**Ship Simulation Transit Scenario Modeling & Ship Pilot Study of the
Maritime Implications for Commercial Ship Transits of the Proposed
Houston Ship Channel Gate Complex**

Prepared for:
Greater Houston Port Bureau

Report Version 7.2, 11/30/2022

Figure 42. Run #34, End of Scenario, Outbound and Second Inbound Ship had Collision

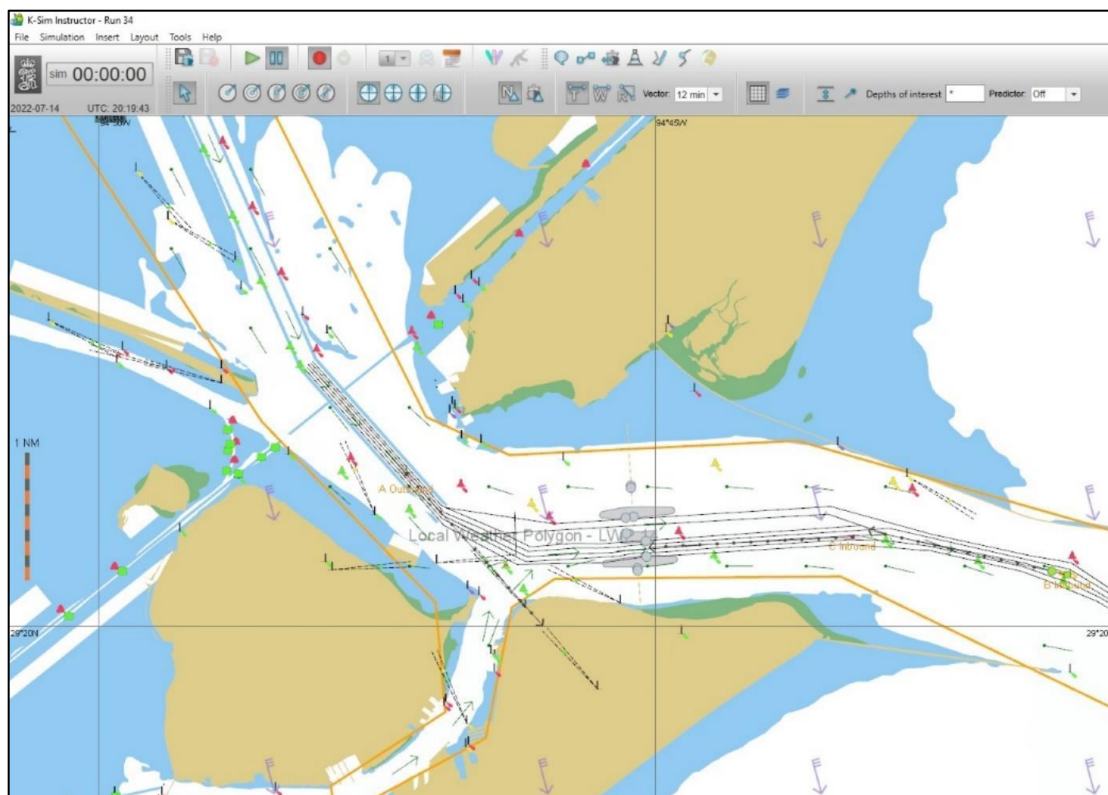
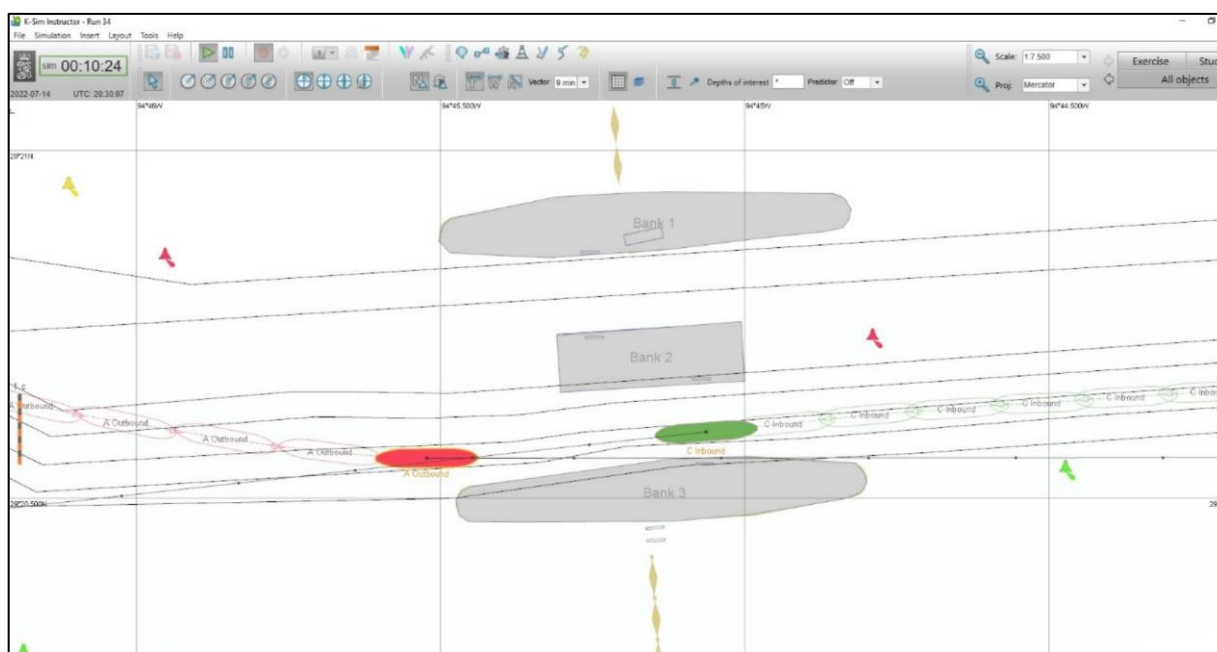
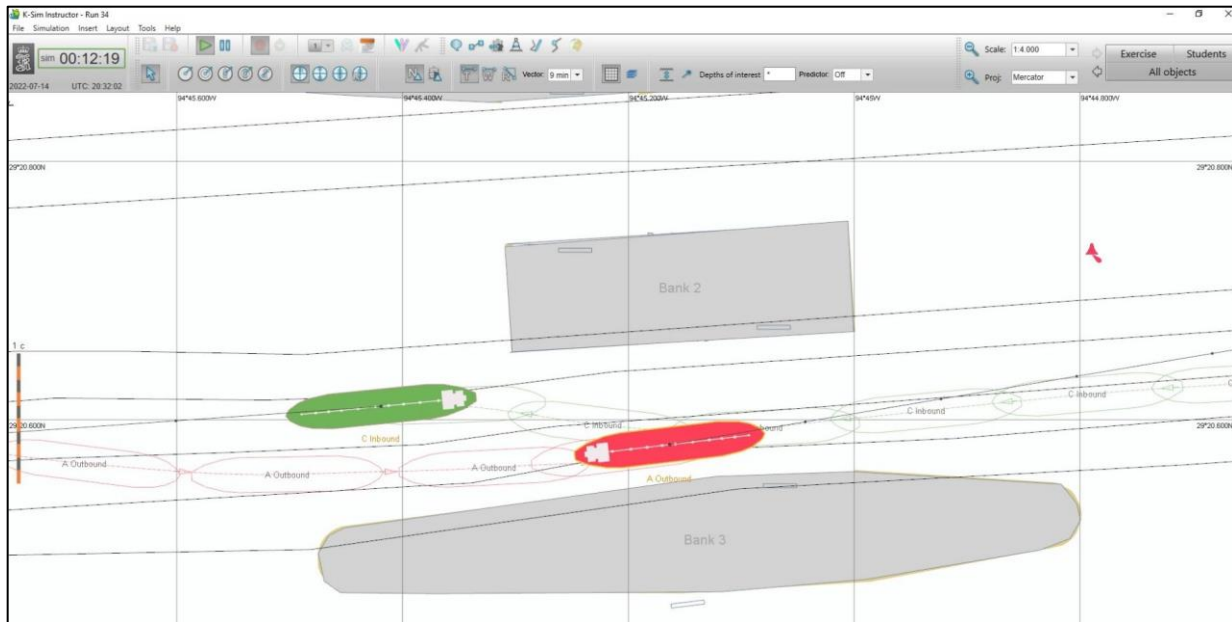
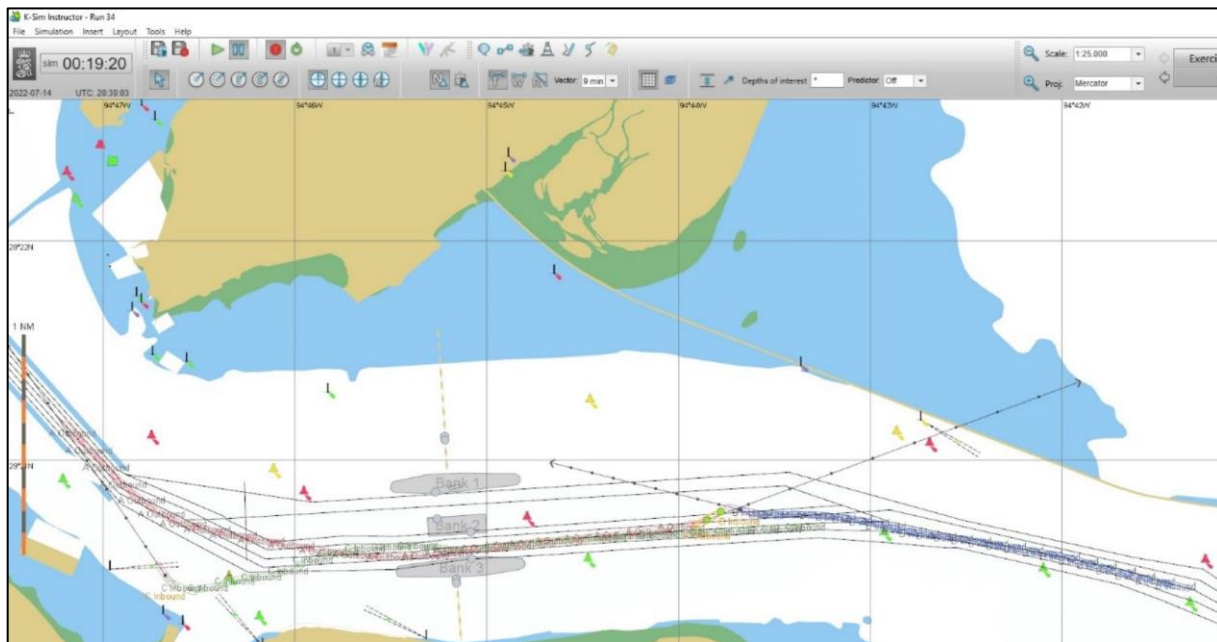
During Run #34, GAR Score 3 High Concern, the outbound ship almost collided with the first inbound ship on the first meeting. This was in part due to miscommunication. The meeting in the gates was preventable. The second inbound ship collided with the outbound ship because it was out of position due to the current. The first inbound ship had a near collision with the outbound ship in the gates. Afterwards, the pilots discussed how the channel and gate complex needs to be wider. The pilot stated, "If they were wider, we could have compensated for a safer meeting."

Figure 45. Run #39, Outbound Vessel Shears off Gate Wall towards Inbound Ship

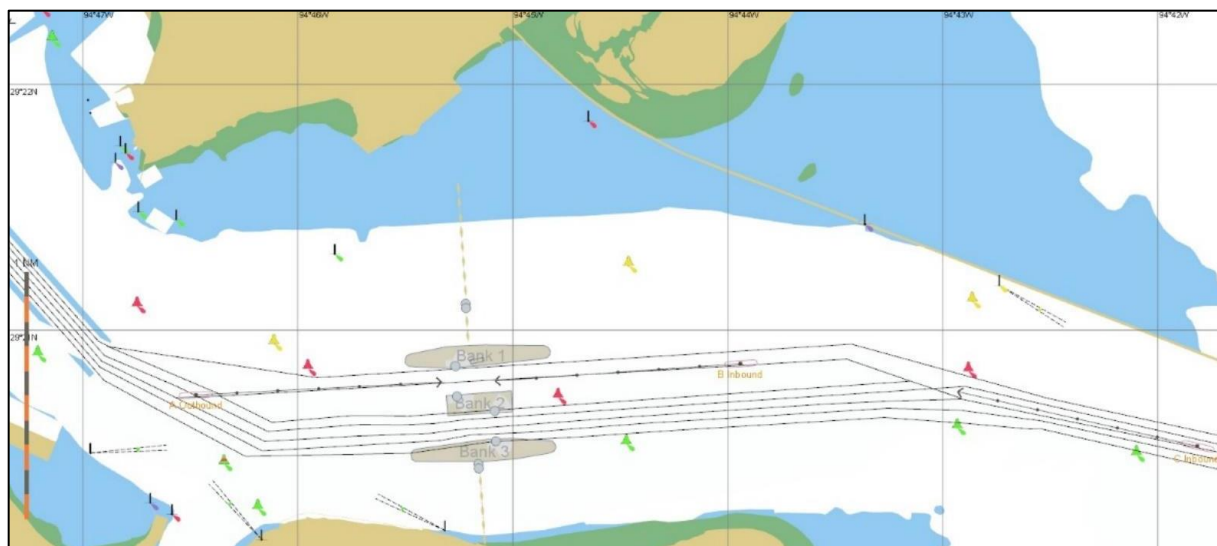
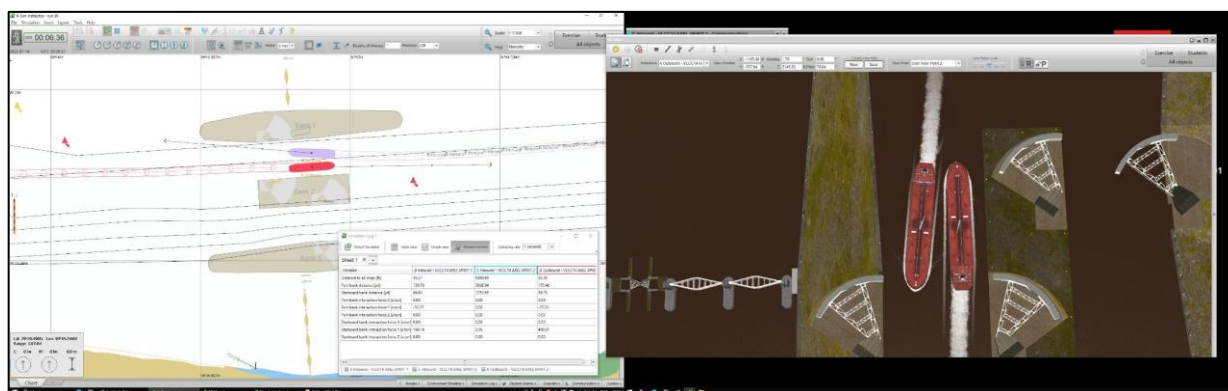
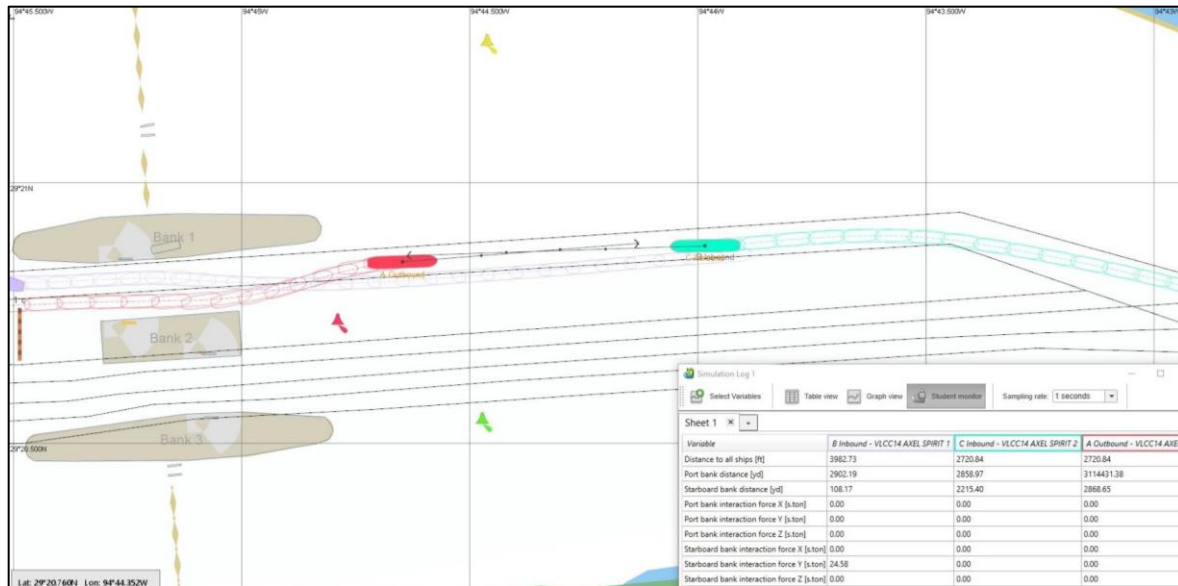
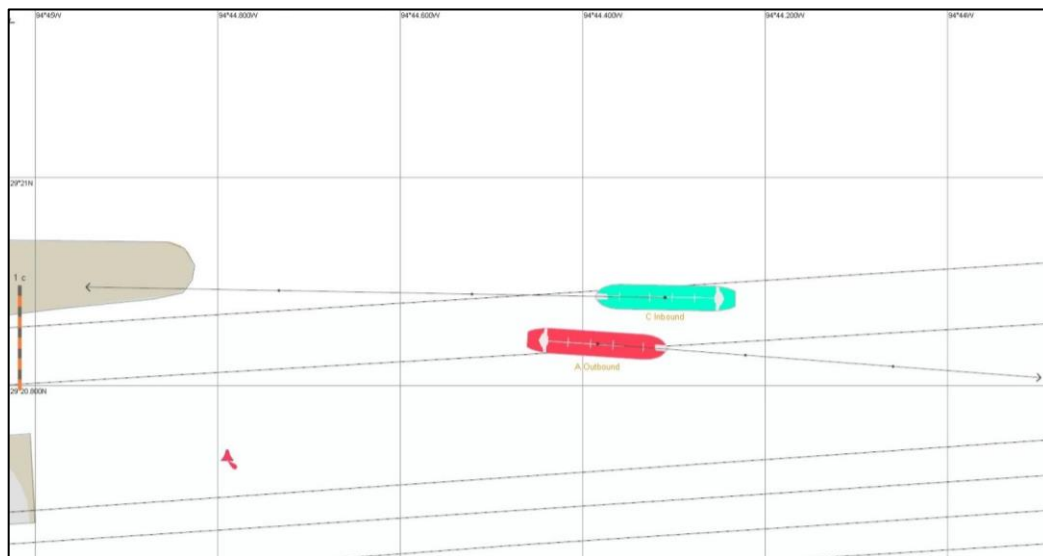
Run #39, GAR score 3 High Concern, had two Aframax-class tank vessel models meet in the north gate complex. The result was a near miss between the ships. The outbound ship experienced shearing forces and was out of position to meet the second inbound ship. After this transit scenario the pilots made multiple recommendations that there should not be any ship meetings within 2 miles of the gates during clear daylight conditions; that there should never be ship meetings inside of the gate complex; and the USCG should establish safety zones in and around the gate complex preventing non-piloted boat and ship traffic from meeting piloted commercial ships. Additionally, the pilots want to research the forces using man model simulation.

Figure 51. Run #40, Containerships Shearing Out of Control Along Gate Walls, Outbound (Red Ship) 322 tons Shearing Forces, Inbound (Blue Ship) 227 tons Shearing Forces

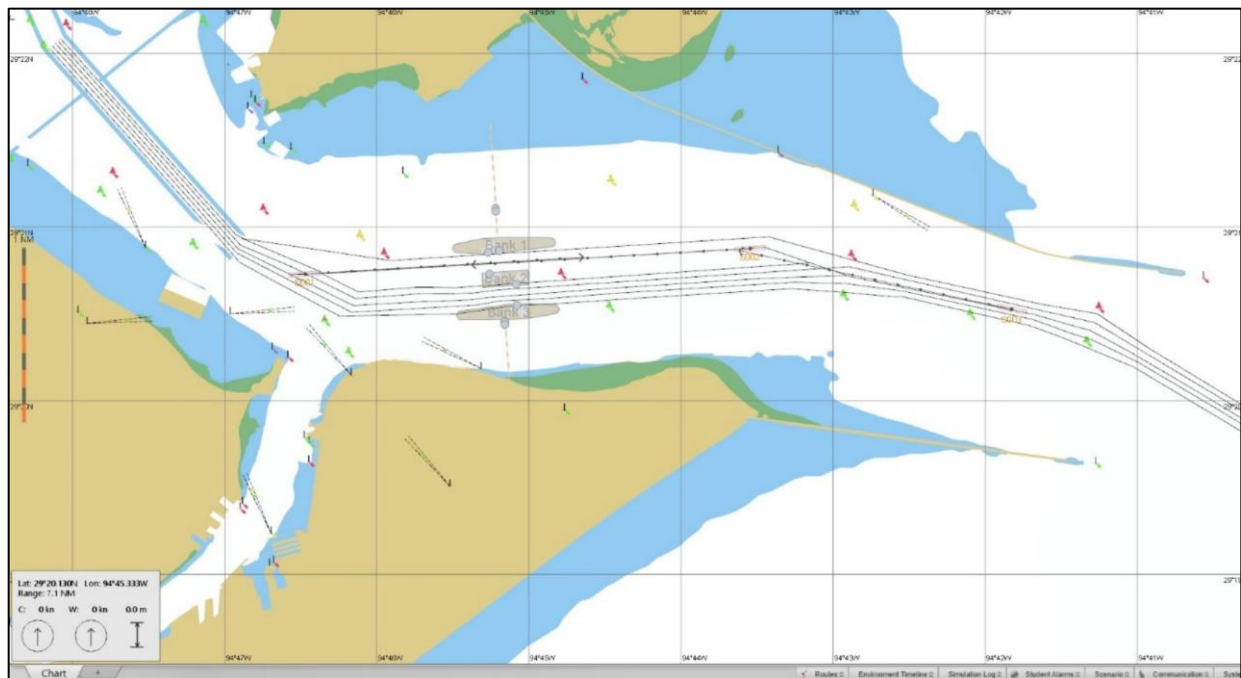
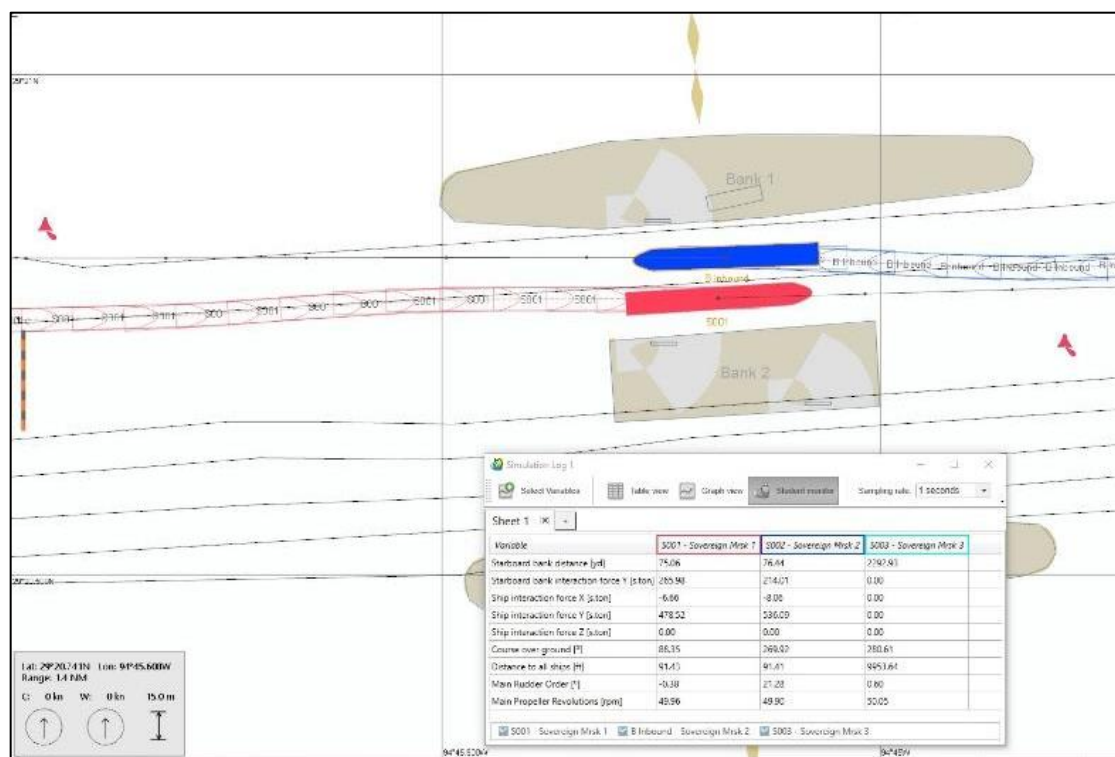
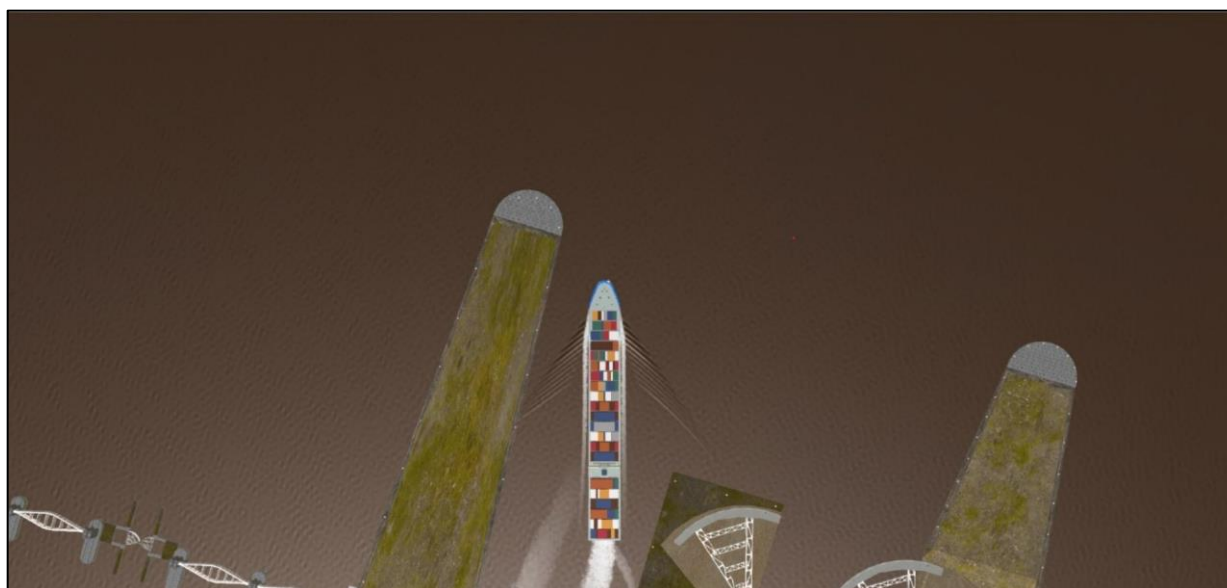
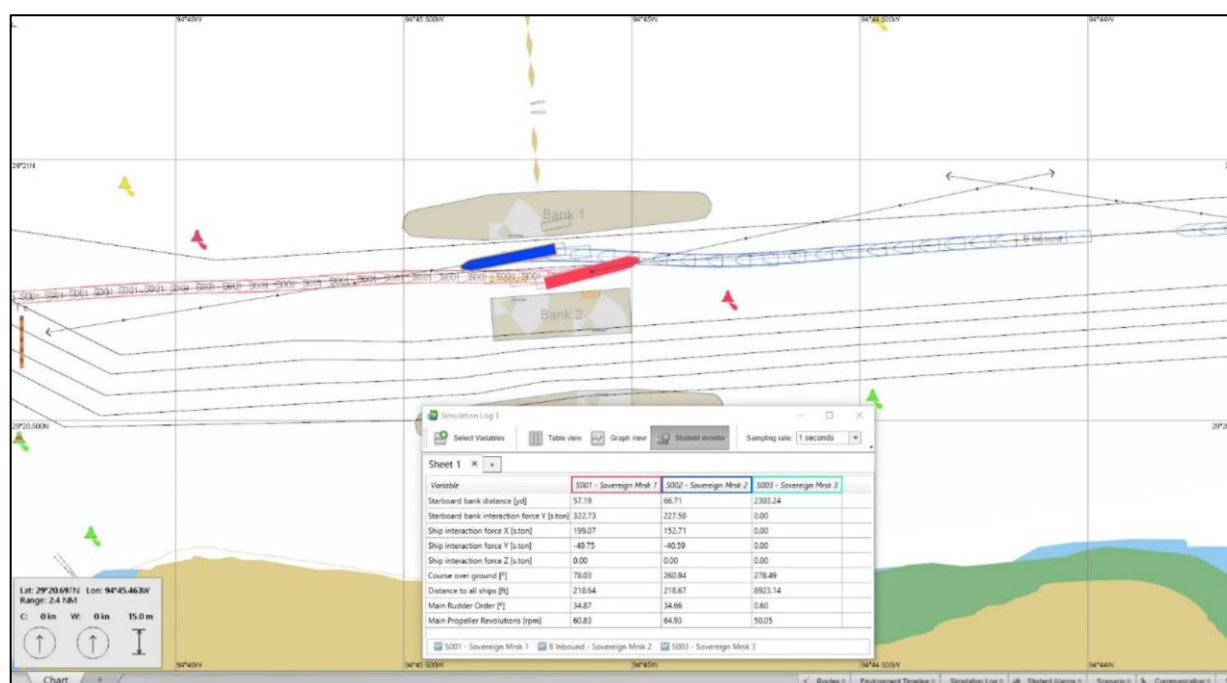
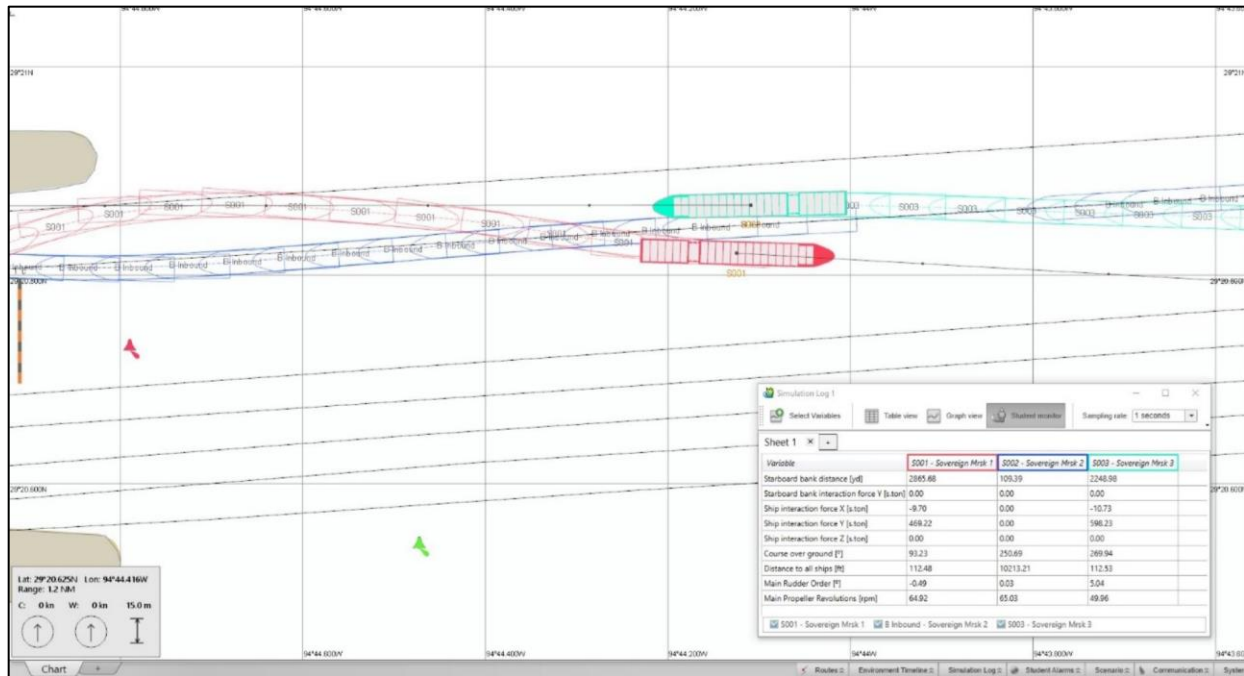
During Run #40, GAR sore 3 High Concern, two container ships, ~1,140 LOA X 140' beam, met in the north gate complex. The result was a near miss between the ships. Both ships afterwards experienced shearing forces. The outbound ship was out of position to meet the second inbound ship. After this transit scenario the pilots made multiple recommendations that the gate complex (650') is too narrow; that the distance between following ships needs to be increased as the current distance of 1 mile is not enough; and that the ships should be able to touch the walls of the gates in an emergency. The pilots also reported losing visibility of the gates during clear daylight conditions aboard these container ships.

Overall, the result of these planned meetings in the north gate complex demonstrated that these commercial ships should not meet in or near the gate complex. Even without current, and in clear daylight conditions, these meetings and transits through the gate complex were a hazard. Furthermore, testing these transits produced many beneficial recommendations such as increasing the following distance between commercial ships, establishing safety zones, widening the gates, the use of manned model simulations to test the designs, and designing the walls of the gates so that they are fendered or designed to reduce damage to vessels if contacted.
